Camden Council comments on Dartmouth Park Neighbourhood Plan, Submission Draft

The comments below are intended to form Camden Council's representation on the submission draft of the Dartmouth Park Neighbourhood Plan and include input from all relevant Council services.

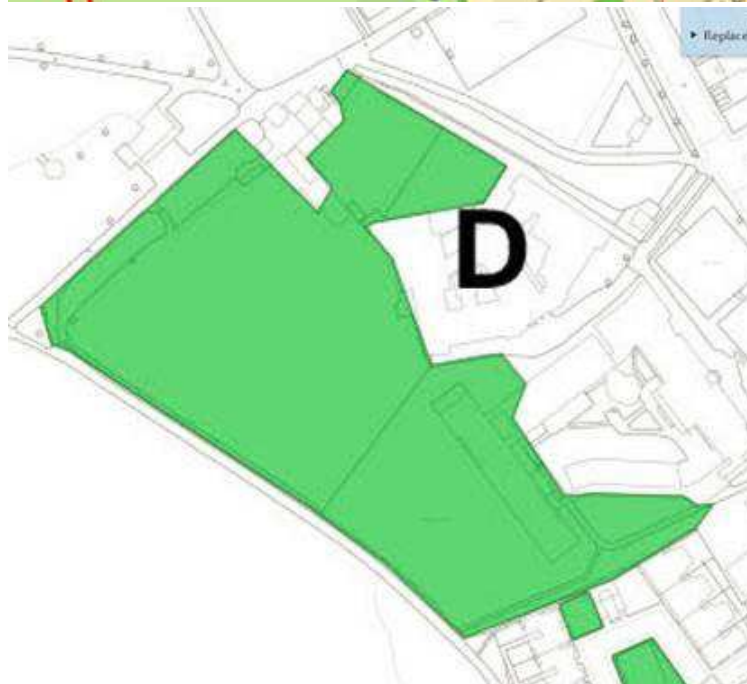
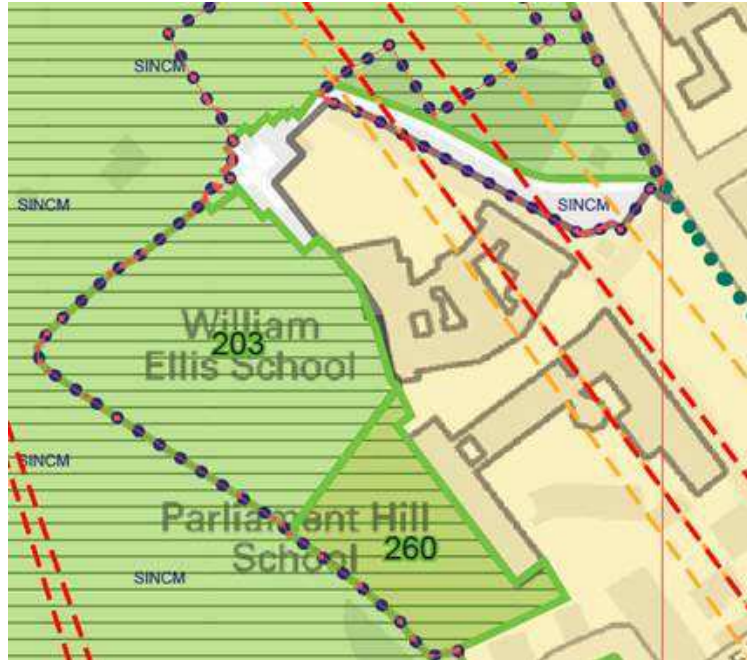
B Community gardens and tennis court, Lissenden Gardens appears to include a third area not referred to in the text and appears to be rear gardens to the mansion blocks not currently designated as open space. It is recommended that area 3 (shown below) is removed or be fully justified in the text.

D Parliament Hill and William Ellis schools and open space.
The mapping includes Parliament Hill School buildings and for both

schools, includes areas not designated as open space on the Camden Policies Map and includes area of hardstanding which are not considered to meet the relevant tests. It is recommended that the maps be amended to match the Policies Map designations as below.

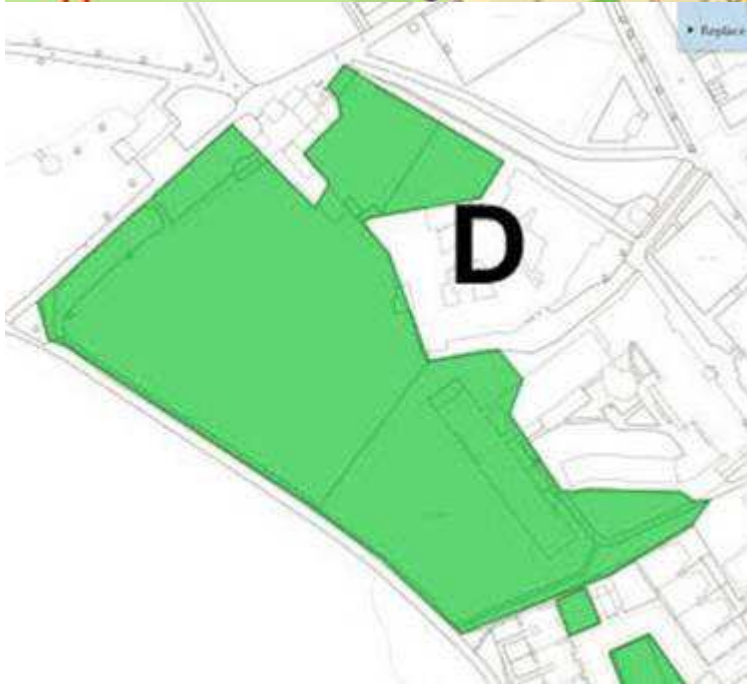
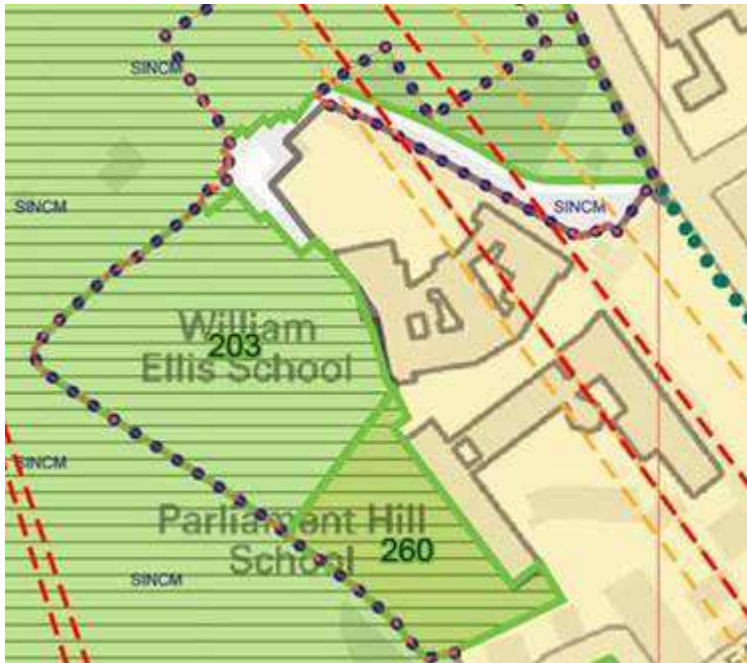
William Ellis is a Voluntary Aided school, London Borough of Camden is the freeholder of the land but it is leased to The Birkbeck and William Ellis Schools Trust on a long term lease for 999 years – I therefore request that the areas highlighted below in Plan D, which are within the school boundaries are removed from the DPNF plan.
